Access Compliance Report

Public Rights-of-Way

(Curb Ramps)

Intersection ID: 48986	Main Street: SARDIS_RD	Cross Street: KINGSDOWN_AV	Location: NW
ADA ID: 4DC0026D3ABD	Ramp Type: PerpDiag	Initial Pass/Fail: Fail	Overall Compliance: No
		Severity Score: 12.5

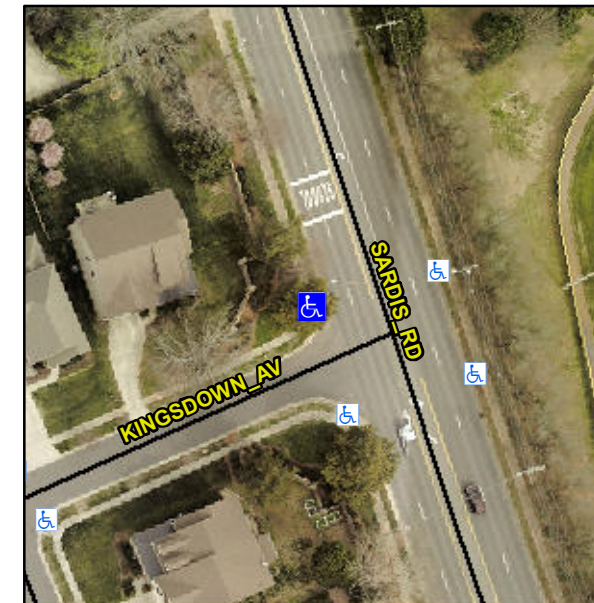
R304.2.2

Compliance	Description	Data	Compliance	Description	Data
N/A	Ramp Length (in)	45.0	No	Ramp Slope (%)	9.8
Yes	Ramp Width (in)	64.0	Yes	Ramp XSlope (%)	1.3
N/A	Flare Type LT	N/A	N/A	Flare Type RT	N/A
N/A	Flare Slope LT (%)	N/A	N/A	Flare Slope RT (%)	N/A
N/A	Flare Traversable LT?	N/A	N/A	Flare Traversable RT?	N/A
N/A	Landing Length (in)	N/A	N/A	DWS Provided?	N/A
N/A	Landing Width (in)	N/A	N/A	DWS Contrast?	N/A
N/A	Landing Slope (%)	N/A	N/A	DWS Length (in)	N/A
N/A	Landing X Slope (%)	N/A	N/A	DWS Full Width?	N/A
N/A	Landing Curb? (Y/N)	N/A	N/A	DWS Offset (in)	N/A
N/A	Shared Landing?	N/A			
N/A	Gutter Ponding?	N/A	N/A	Gutter Slope (%)	N/A
N/A	Gutter Lip Ht (in)	N/A	N/A	Gutter X Slope (%)	N/A
N/A	Painted X Walk1?	No	N/A	Painted X Walk2?	No
	X Walk 1 Direction	To S		X Walk 2 Direction	To E
N/A	X Walk 1 Width (in)	N/A	N/A	X Walk 2 Width (in)	N/A
	X Walk 1 Slope (%)	1.2		X Walk 2 Slope (%)	1.5
	X Walk 1 X Slope (%)	0.3		X Walk 2 X Slope (%)	1.7

Remove & Replace Curb Ramp With Two New Directional Ramps or Equivalent.
